RE: **P.Z. 03-2020 Downtown Chesterfield (Wildhorse Village, LP)** An ordinance amending City of Chesterfield Ordinance 3023 to amend the legal description and development criteria for an existing PC&R Planned Commercial and Residence District for a 99.6 acre tract of land located west and southwest of the intersection of U.S. Highway 40/I-64 and Chesterfield Parkway West (18T620185, 18T620206, 18T620053, 18T630272, 18T630195, 18T640248, 18T640260, 18T640271, 18T620174, 18T640183, 18S410240, 18S410206, 18S430259, 18S430282, 18T640336, 17T320158, 18T640237, 18T640259, 18T620064, 17T320169).

Planning Commission Staff Report

Petition: **P.Z. 03-2020 Downtown Chesterfield (Wildhorse Village LP.)**: An ordinance amending City of Chesterfield Ordinance 3023 to amend the legal description and development criteria for an existing PC&R Planned Commercial and Residence District for a 99.6 acre tract of land located west and southwest of the intersection of U.S. Highway 40/I-64 and Chesterfield Parkway West (18T620185, 18T620206, 18T620053, 18T630272, 18T630195, 18T640248, 18T640260, 18T640271, 18T620174, 18T640183, 18S410240, 18S410206, 18S430259, 18S430282, 18T640336, 17T320158, 18T640237

GROUND FLOOR ACTIVITY

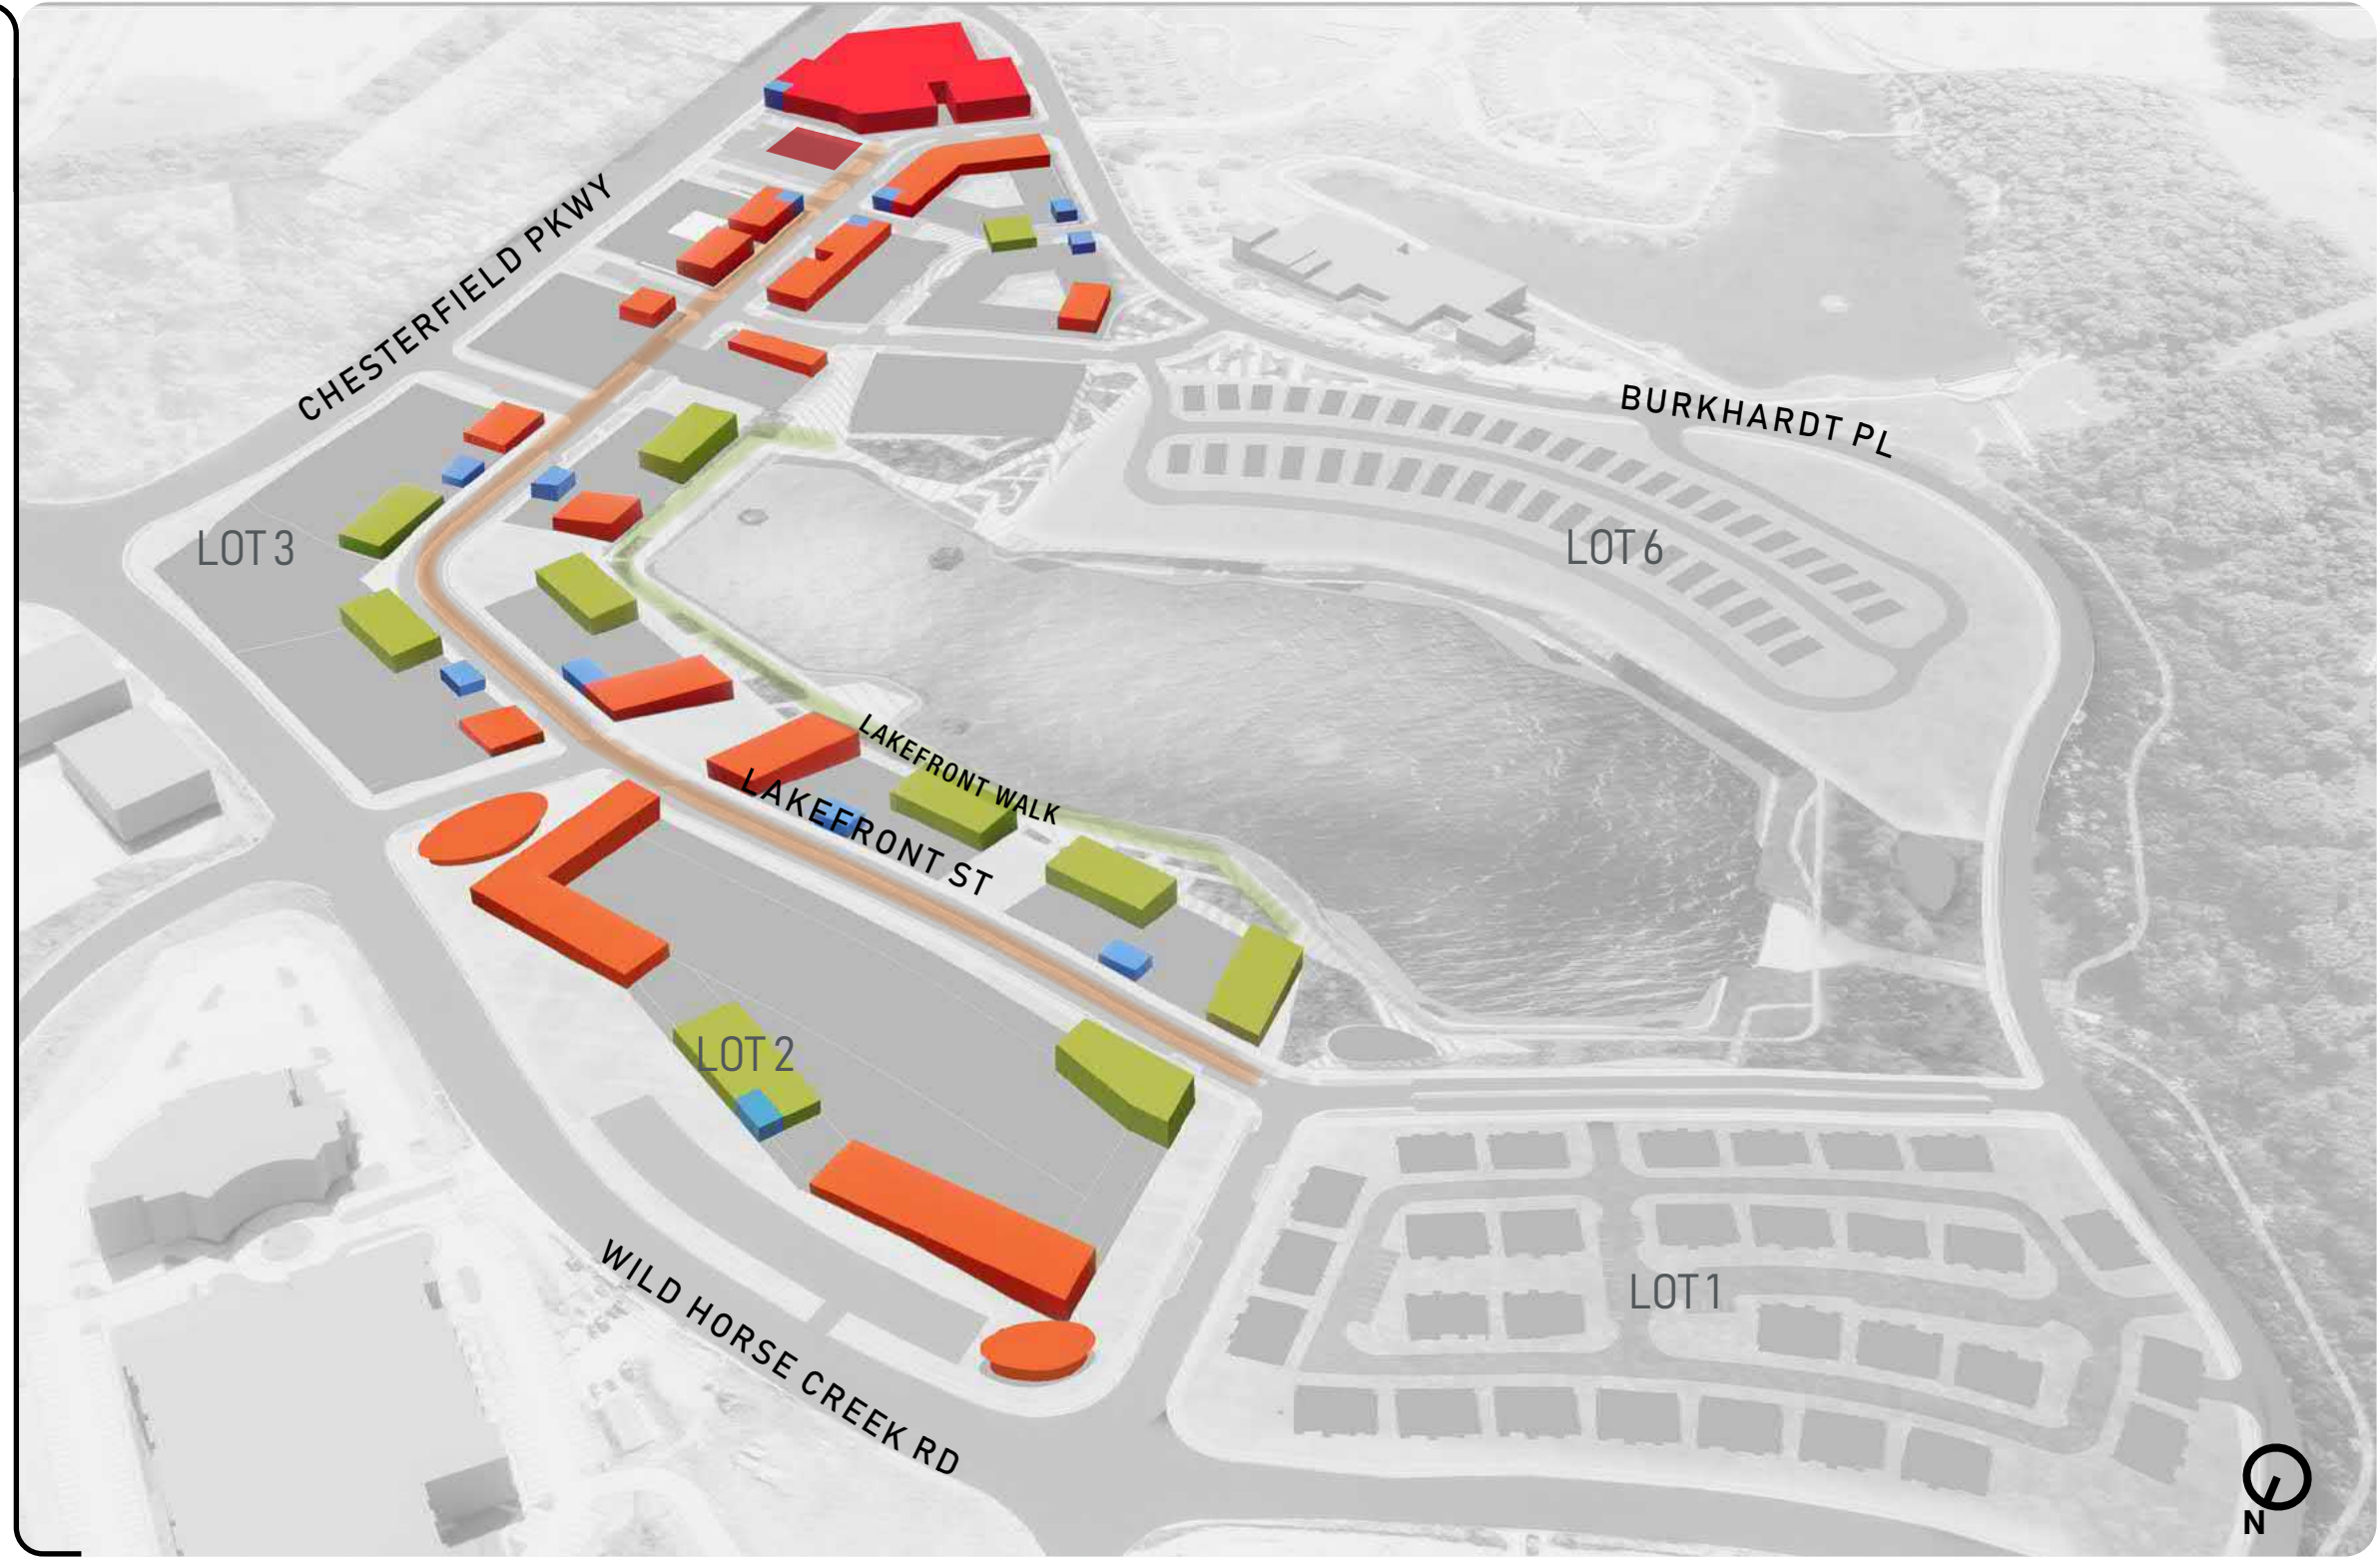
2. It was acknowledged by the Planning Commission that they were comfortable with not having first-floor retail on all buildings, but there was a desire to see retail remain on the first floor of some buildings. A statement was made to establish a retail threshold that could be used to understand how much retail would be integrated into the buildings.

4. There was concern from residents on removing the requirement for retail commercial on the first floor along the Lake Front Street. Provide information on how first-floor pedestrian activities and architectural design will remain along the Lake Front Street with or without retail.

Response: The intent is to provide retail within both Category A & B which front Wild Horse Creek Road, Chesterfield Parkway West, Lakefront Street & along the Lakefront Walk. (see Ground Floor Activity slide in the LJC Exhibit)

Response: (see the Ground Floor Activity slide in the LJC Exhibit)

LAKEFRONT ST CONNECTIVITY TO LAKE

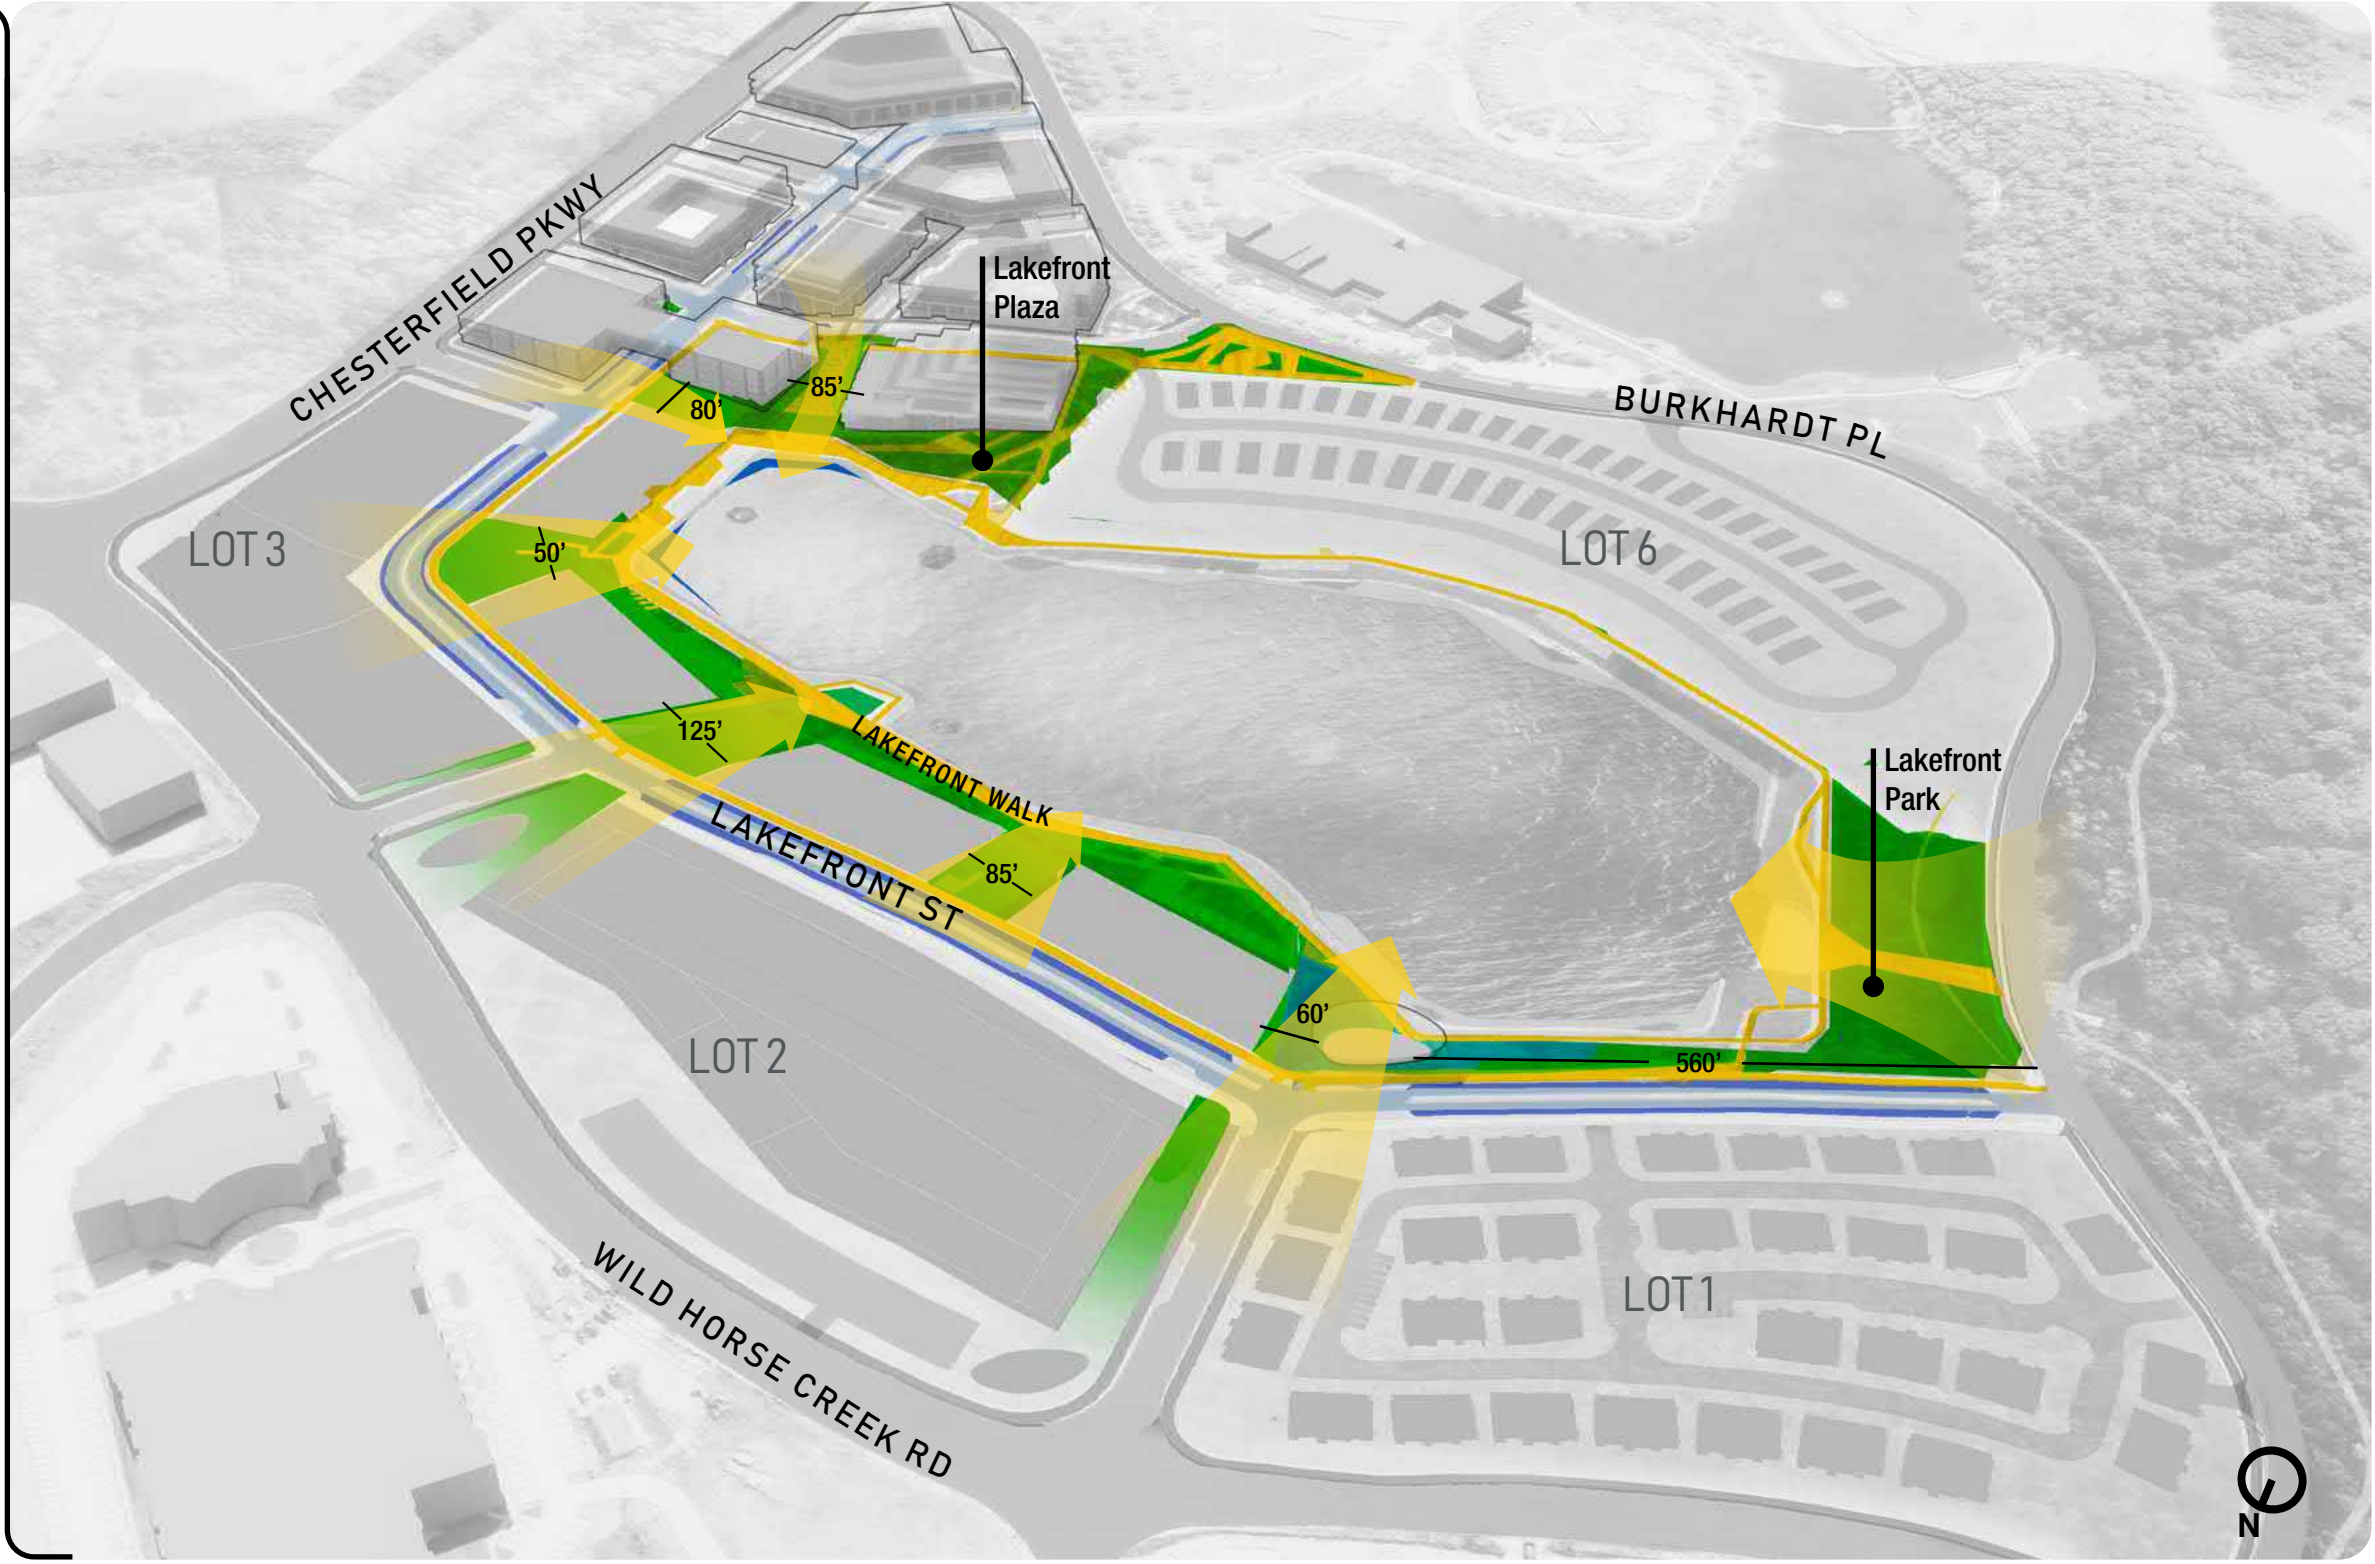
8. There was a concern from residents about having buildings on both sides of the Lake Front Street. A desire was stated to minimize the amount of building on the lake side of a Lake Front Street. Provide a further explanation on the interaction of development between the Lake Front Street and the lake.

Response: The office/mixed-use areas will incorporate buildings on both sides of Urban Main Street or “Lakefront Street” with engagement to the lake front trail that encourages pedestrian interaction with the water and amenities being constructed as part of the public realm. (see the Lakefront Street Connectivity to Lake slide in the LJC Exhibit)
